**TO:** George Huddleston; Darryl DeYoung  
**FROM:** Clarissa Davis, Planner  
**RE:** Lawnwood Pavilion; Conditional Use w/ New Construction & Design Review  
**DATE:** May 18, 2015

**SUBJECT:** Lawnwood Pavilion Expansion – Site Plan w/ CU  
1850 N. Lawnwood Circle  
Technical Review Project No. 15-07000002

**RE: Lawnwood Physical Rehabilitation Center Expansion  
City of Fort Pierce Comment Response  
Fort Pierce, FL  
Project No. 20150322**

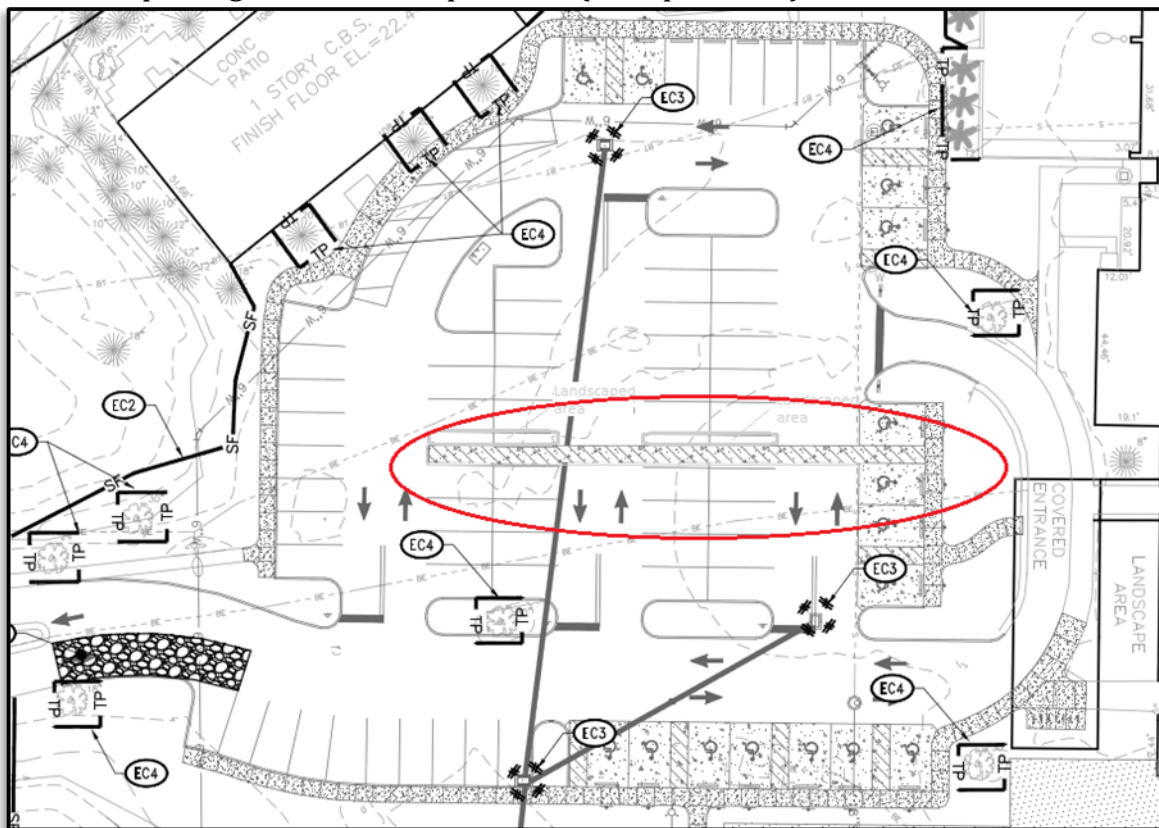
3. Additional trees in east property line needed.

**Code Section 22-187(4)b** - The landscape strip shall include an average of at least one tree for each three hundred (300) square feet of required landscaped area. The remainder of the required landscaped area shall be completely covered with grass, ground cover or other landscaped treatment and shall additionally contain a screen of landscaping which shall be installed and maintained so as to form a thirty-six-inch or higher continuous, unbroken, solid, visual screen within a maximum of one year after the landscaping takes place, except in clear vision areas required in section 22-53.

3. Additional trees in east property line needed.
  - *As discussed, the current buffer along South 21<sup>st</sup> Street is more bare than the east property line. A landscape buffer that complies with Sec. 22-187(4) has been added to Sheet L1.0.*
